Date: June 20, 2001

To: T10 Committee (SCSI)

Subject: Long Identifiers in SPC-3, SAM-2, SBC-2 and other XOR issues

Table xx1. CHANGE ALIASES command.

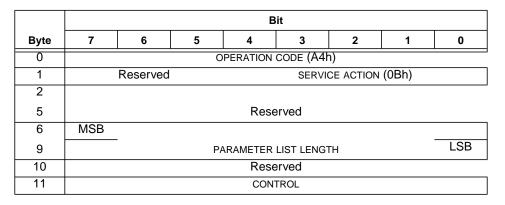
The CHANGE ALIASES command (see Table xx1) requests that the device server maintain and make changes to a list of associations between eight byte alias values and SCSI device or port designations. A designation contains a name and optional addressing information that identifies a SCSI device or port (see 7.xx.3). The alias list may be queried by the initiator via the REPORT ALIASES command (7.yy). If the REPORT ALIASES command is supported then the CHANGE ALIASES command shall also be supported.

The PARAMETER LIST LENGTH field specifies the length in bytes of the parameter data that shall be transferred from the application client to the device server. A parameter list length value of zero indicates that no data shall be transferred and no changes shall be made in the alias list.

If the parameter list length results in the truncation of the header or any alias entry, then the device server shall make no changes to the alias list and terminate the command with CHECK CONDITION status. The sense key shall be set to ILLEGAL REQUEST and the additional sense code shall be set to PARAMETER LIST LENGTH ERROR.

If the device server processes a CHANGE ALIASES command that contains at least one alias entry (see Table xx2) while there exists any other enabled task that references an alias entry in the alias list, the device server shall terminate the CHANGE ALIASES command with CHECK CONDITION status and sense key set to ILLEGAL REQUEST. The additional sense code shall be set to OPERA-TION IN PROGRESS.

Table xx2. CHANGE ALIASES and REPORT ALIASES parameter list.

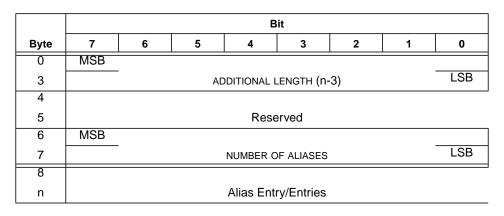
The format of the parameter data for the CHANGE ALIASES and REPORT ALIASES is specified in Table xx2. It contains a header that indicates the amount of additional data, and the number of entries in the alias list.

The ADDITIONAL LENGTH field specifies the number of bytes in the remaining parameter data. For the REPORT ALIASES command, the value of this field shall contain the actual number of bytes available in the parameter data and shall not be changed if the CDB contains insufficient allocation length.

For the CHANGE ALIASES command, the NUMBER OF ALIASES field is reserved. For the REPORT ALIASES command, the NUMBER OF ALIASES field indicates the number of alias entries in the alias list and shall not be changed if the CDB contains insufficient allocation length.

For the REPORT ALIASES command, if there are no alias entries in the alias list, then the ADDITIONAL LENGTH field shall be set to four and the NUMBER OF ALIASES field shall be set to zero.
